ADDENDUM 02

No. ELE-002-R1

Client:	Conseil des écoles catholiques du Centre-Est	
Project:	École Élémentaire Catholique J.-L. Couroux	
Project No.:	25-1159	
Description:	Revisions to drawings and clarifications to specifications	
Division(s):	26	
By:	Nicole Lemieux April Waddell, P. Eng	Date: 2026-08-07

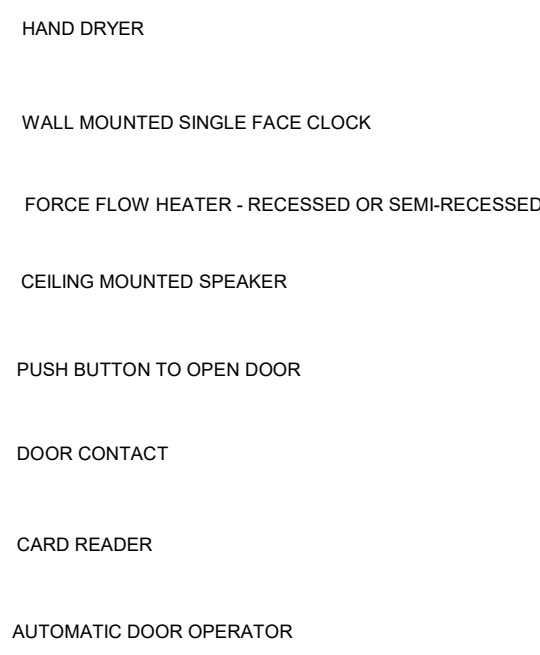
Q: *Drawing E-103 Details 6,7,8,9 show cable tray or show J hooks but nothing is shown on the drawings. Please clarify if they are needed?*

A: *J-hooks are permissible above accessible ceilings within classrooms only. Conduits are to be used in inaccessible ceiling spaces, from classrooms to the cable tray and from device boxes to the ceiling space. All cables are to be supported, coordinate all pathway requirements, rough-ins and backbox placements with the designated contractor. Refer to general notes on drawing E-301.*

1 PARTIAL SINGLE LINE DIAGRAM - DEMOLITION

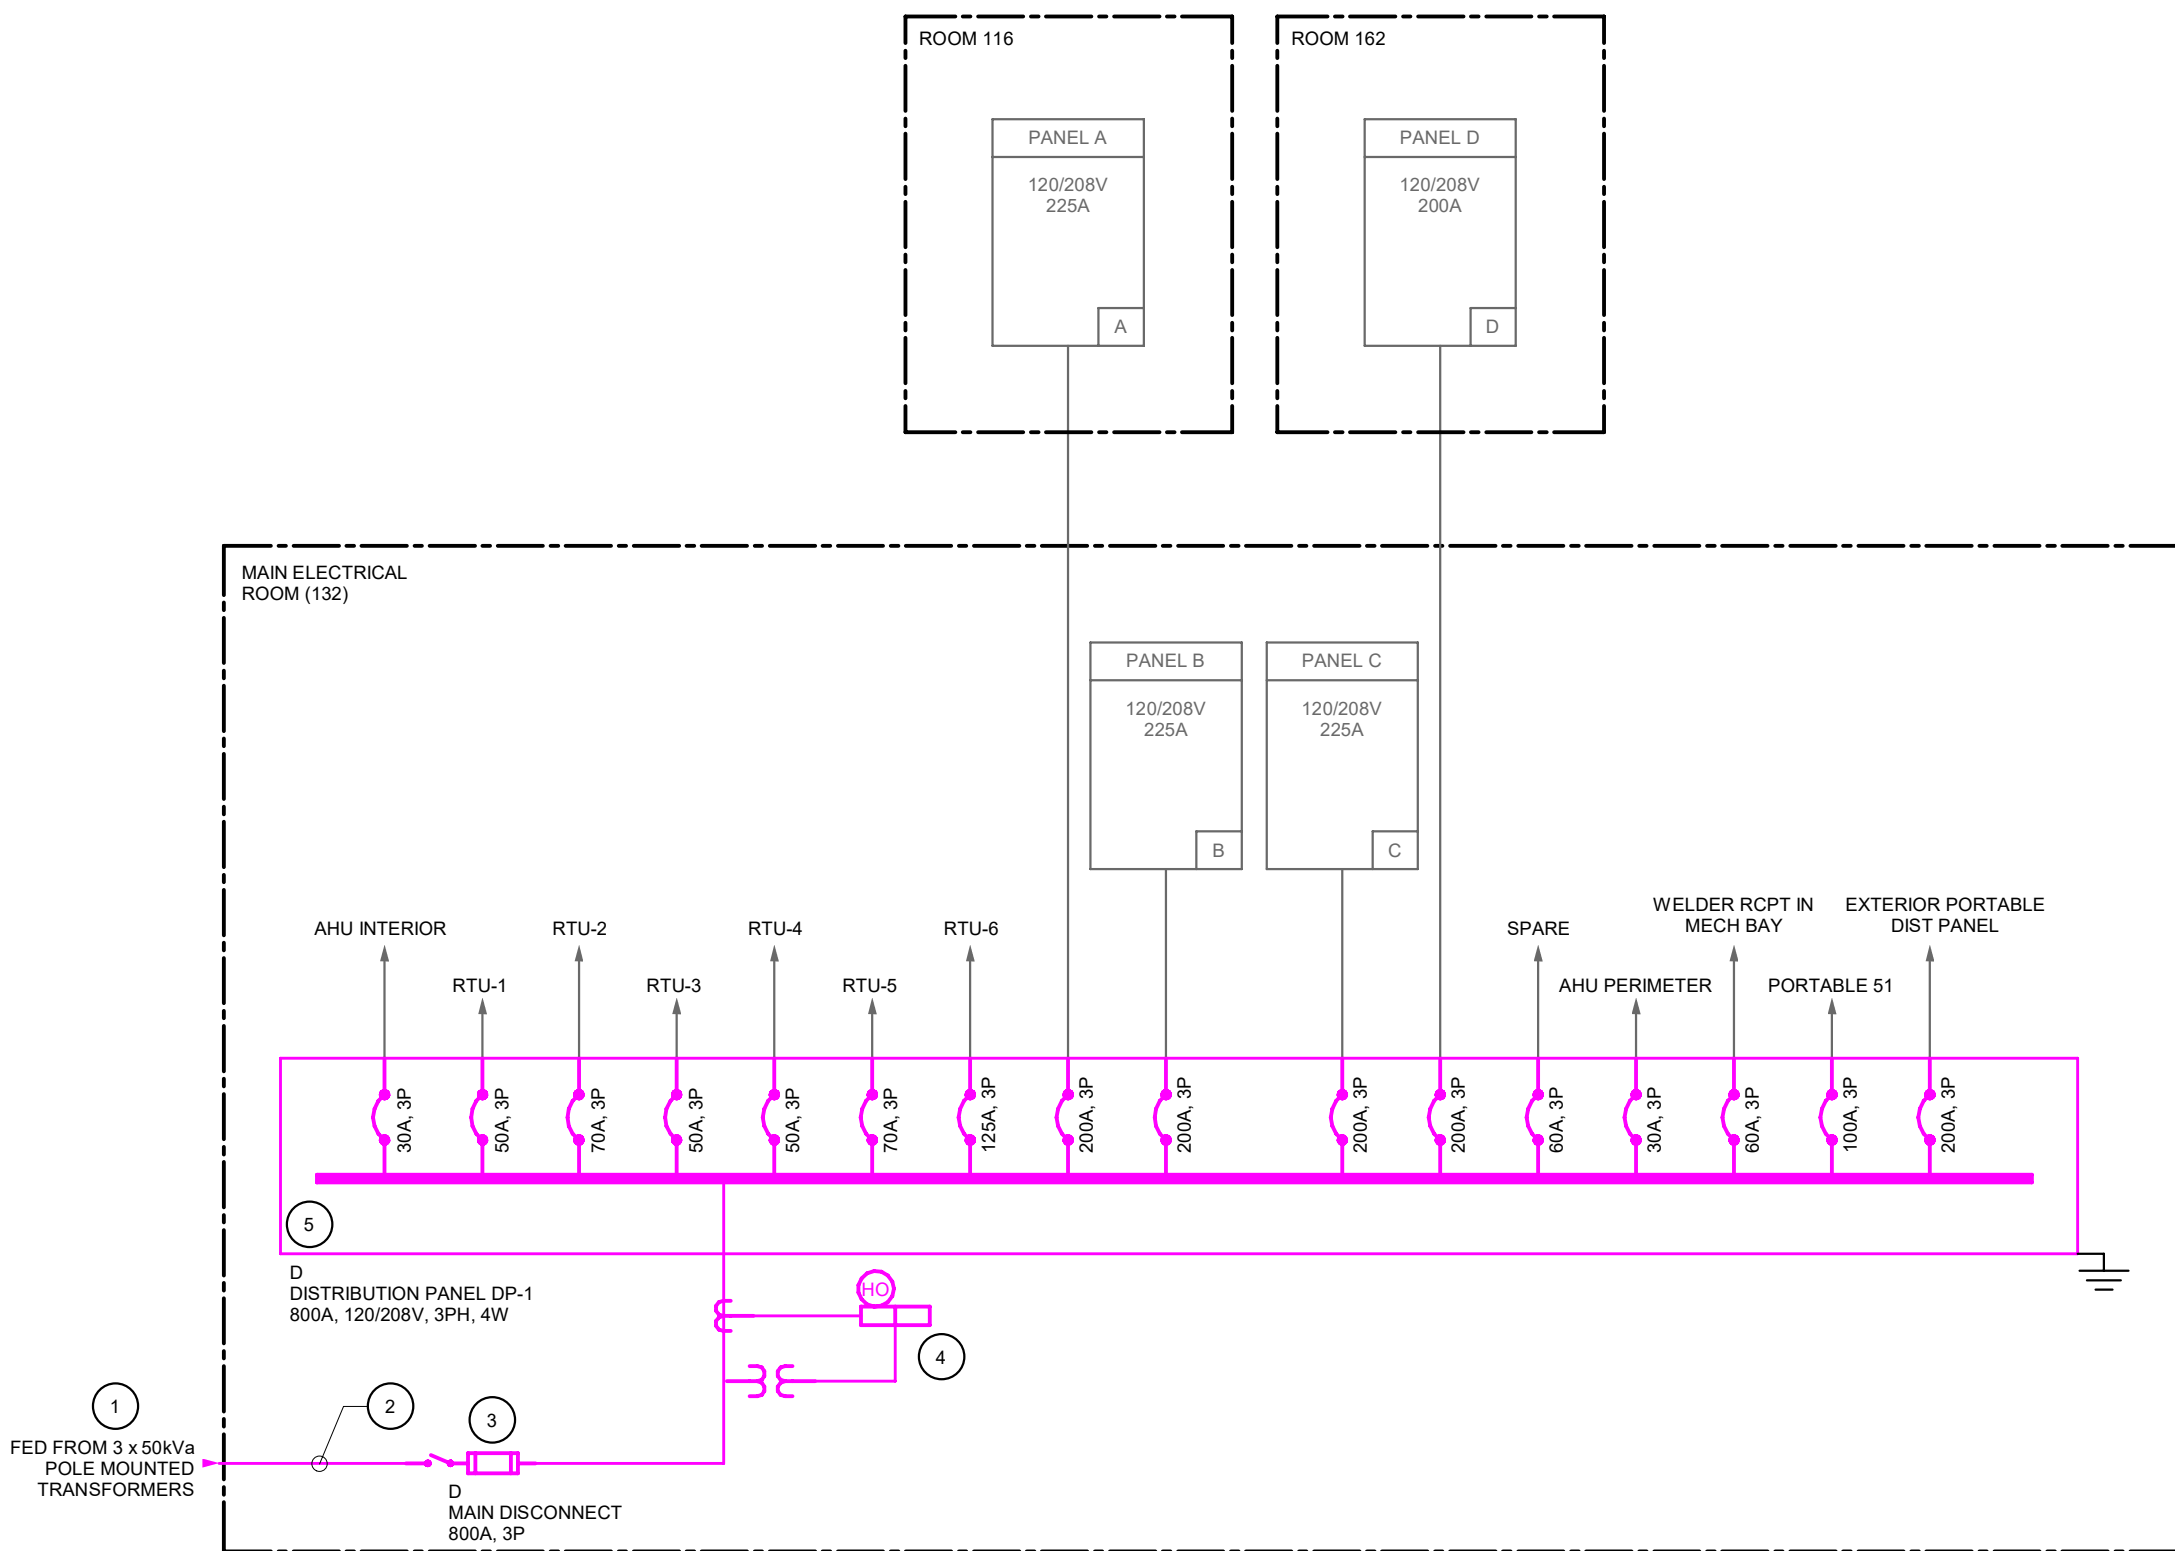
- Refer to drawing for revised details 2 & 3.

2 PARTIAL SINGLE LINE DIAGRAM - NEW WORK

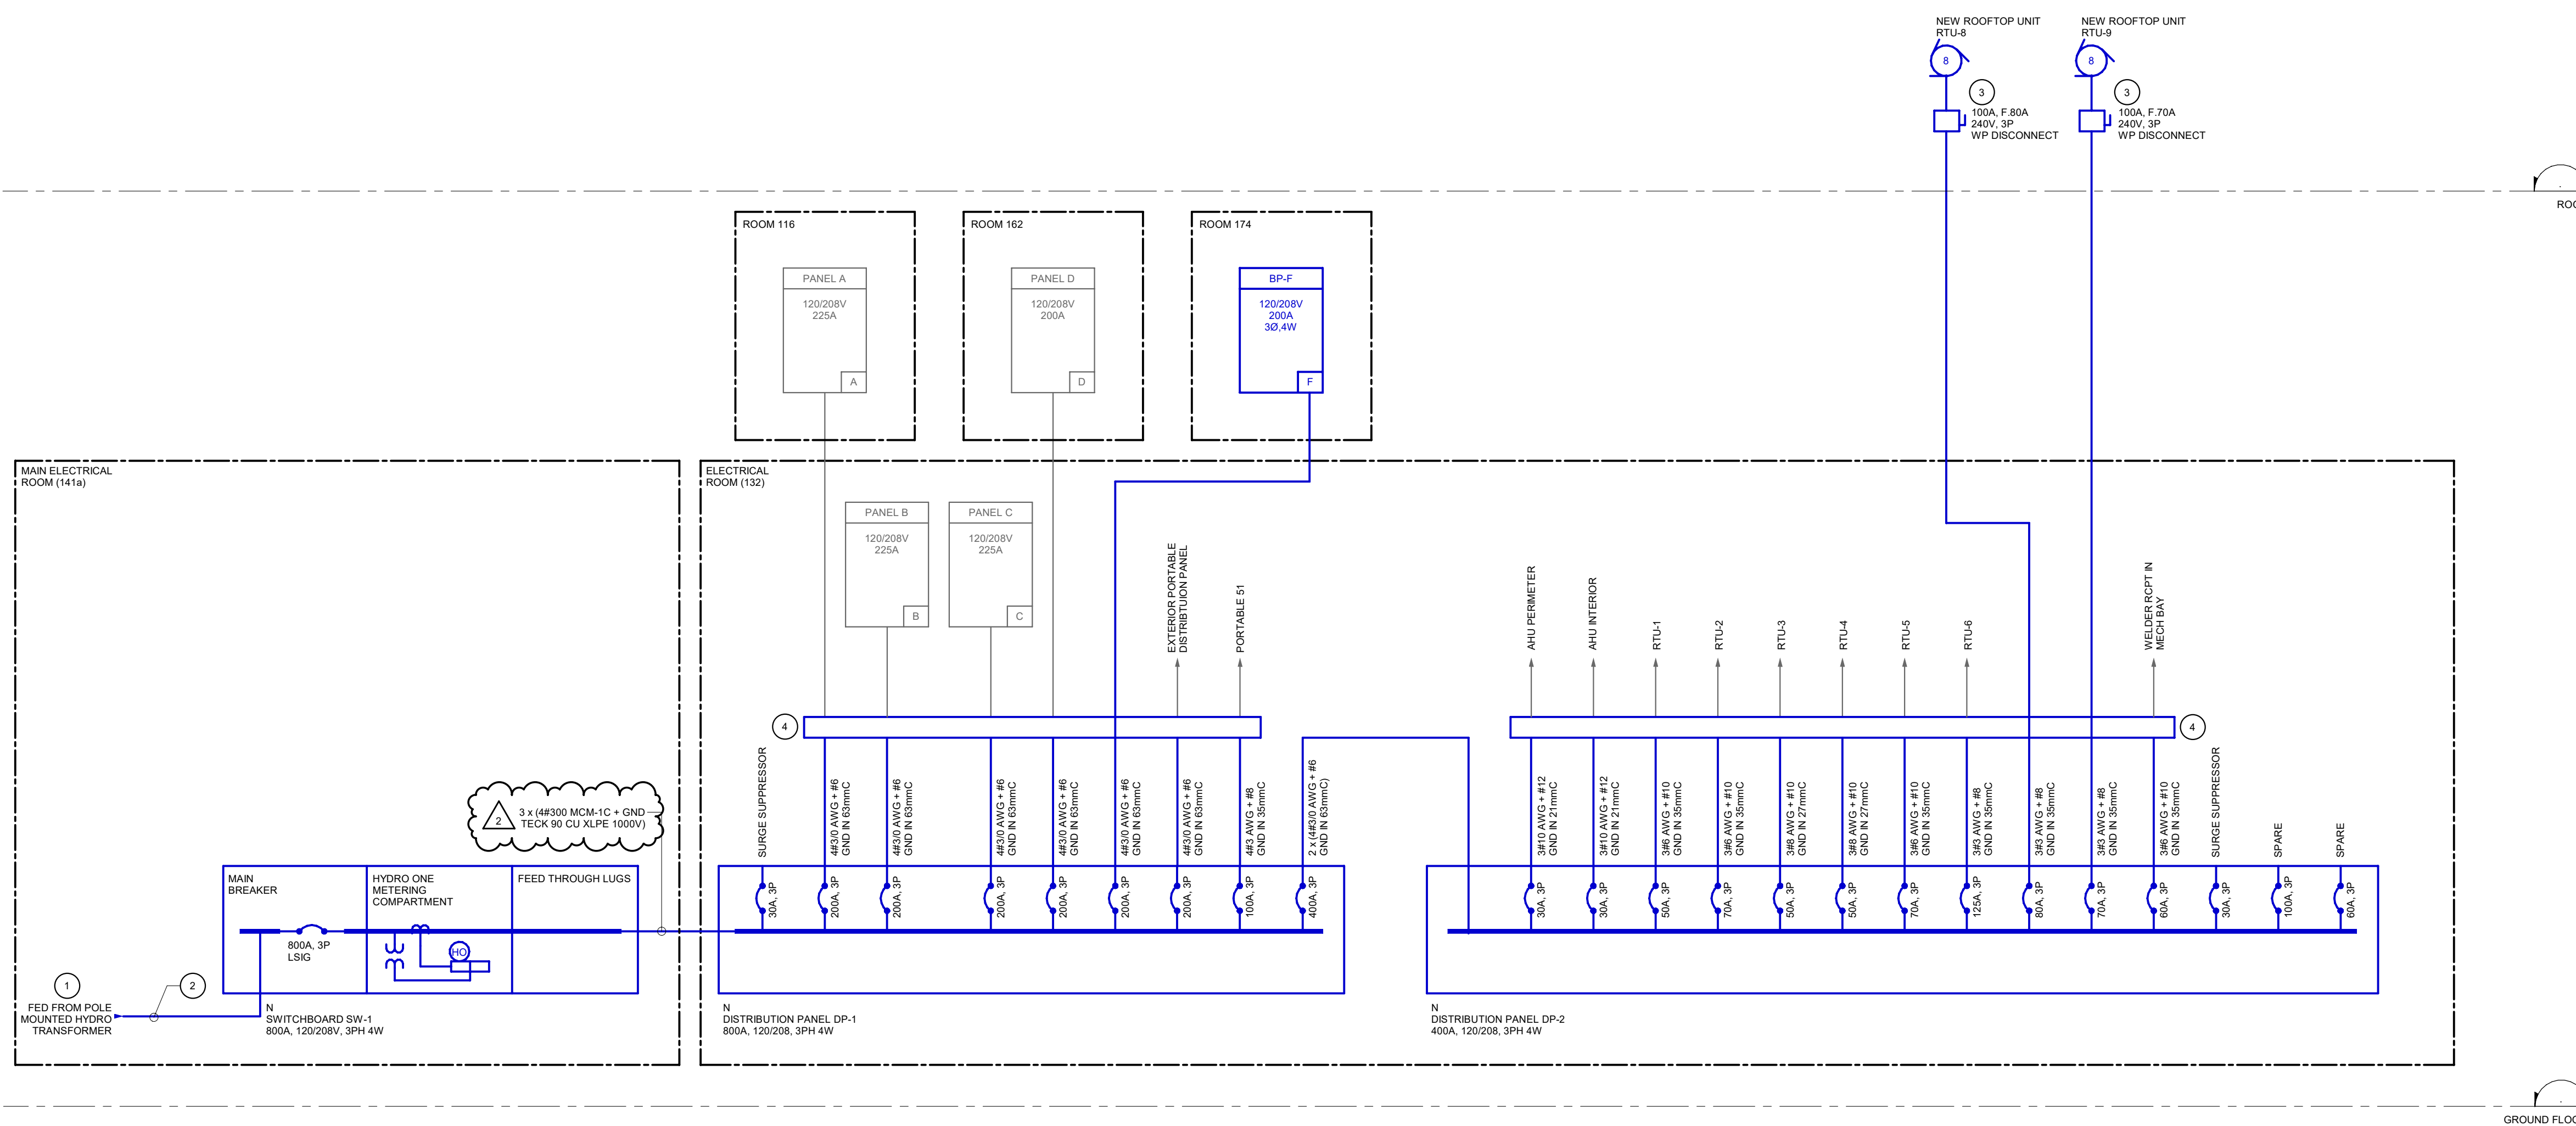
- Revise feeder from hydro pole to switchboard SW-1 from 4#900 MCM + #2/0 GND to 2 x (4#600 MCM + #2 GND).
- Revise feeder from switchboard SW-1 to DP-1 from 2 x (4#350MCM-1C + GND TECK 90 CU XLPE 1000V) to 3 x (4#300MCM-1C + GND TECK 90 CU XLPE 1000V).

1 POWER & SERVICES - GROUND FLOOR - NEW WORK
E-301 1: 100

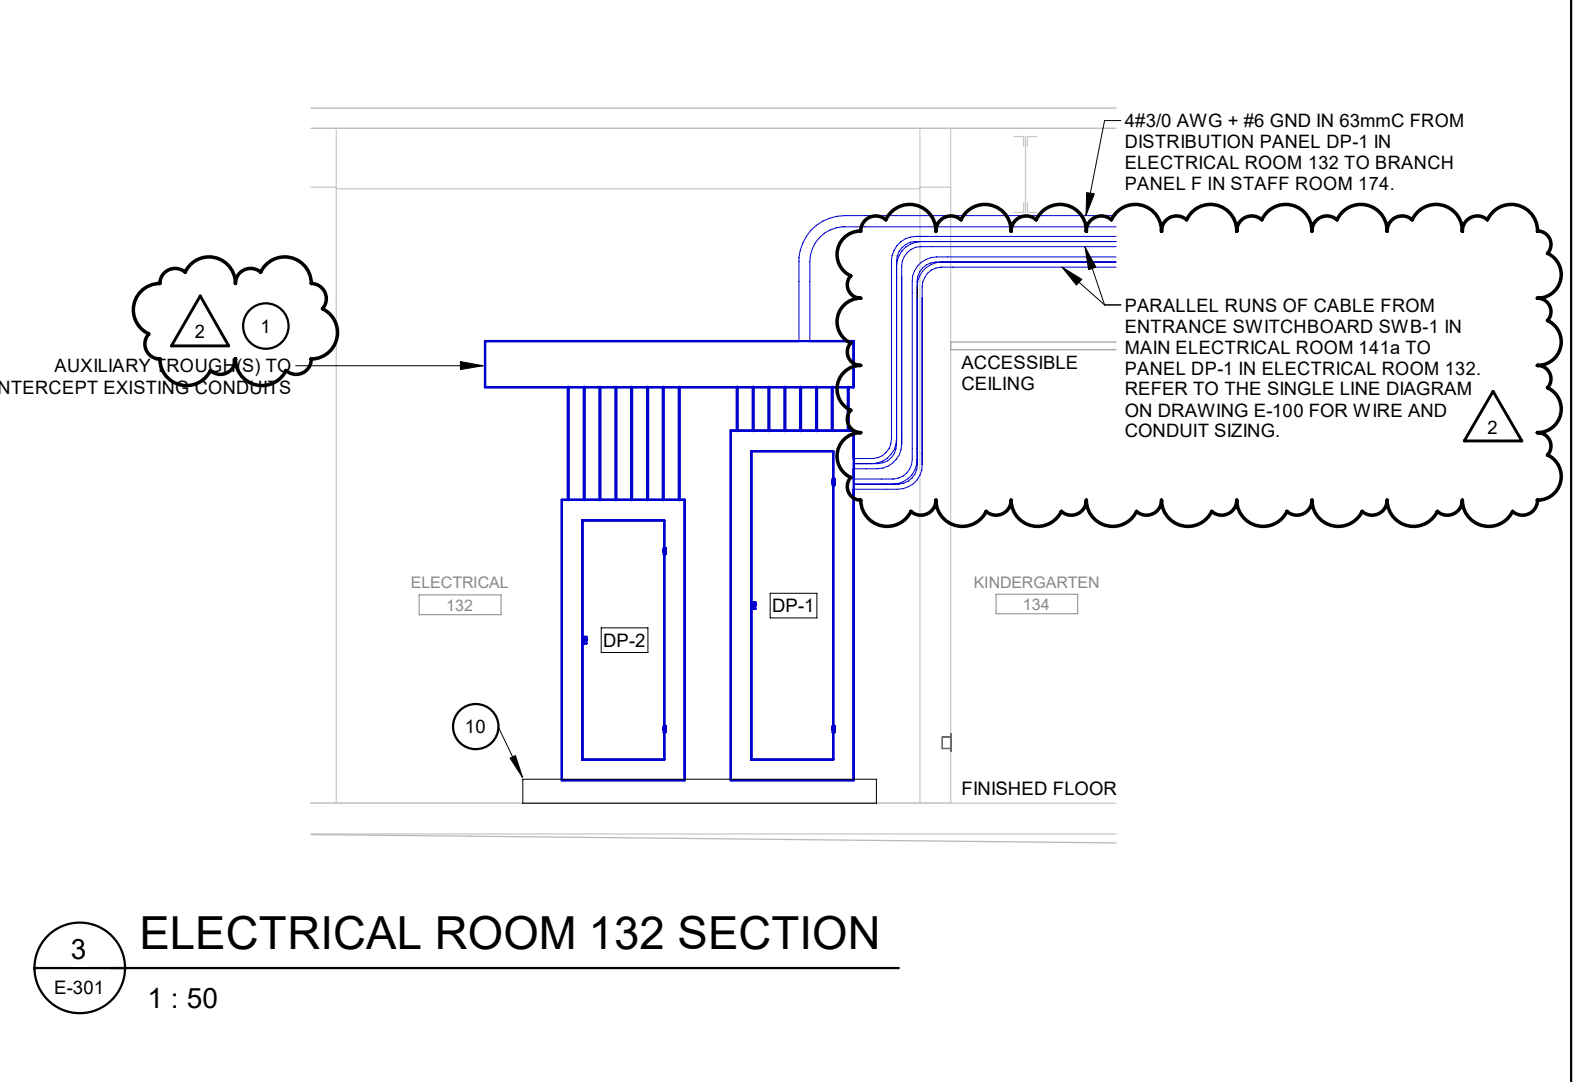
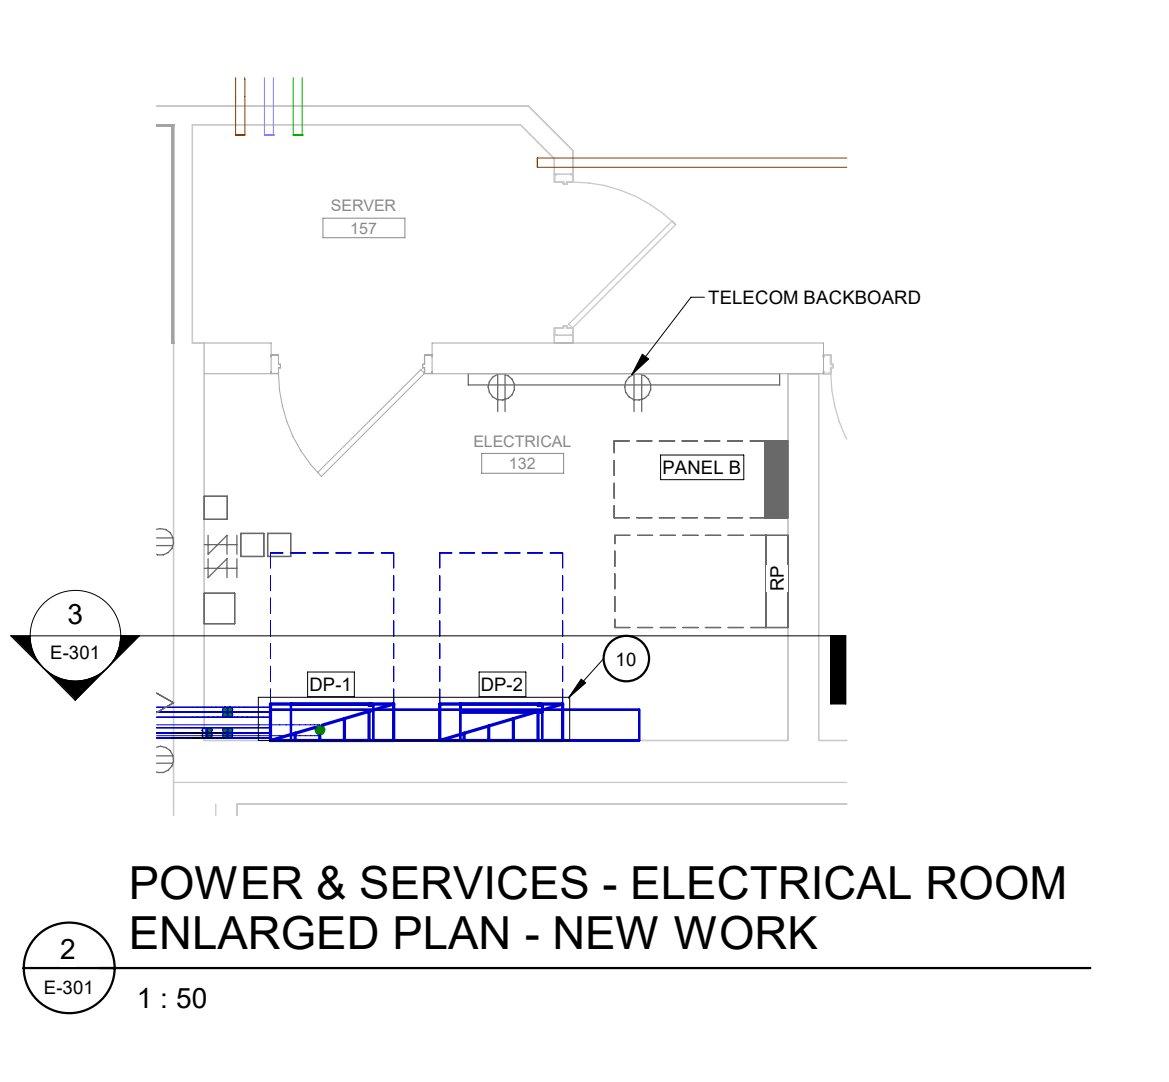
- Refer to drawing for revised notes and cable run.
- Refer to drawing for references to details on drawing E-103.
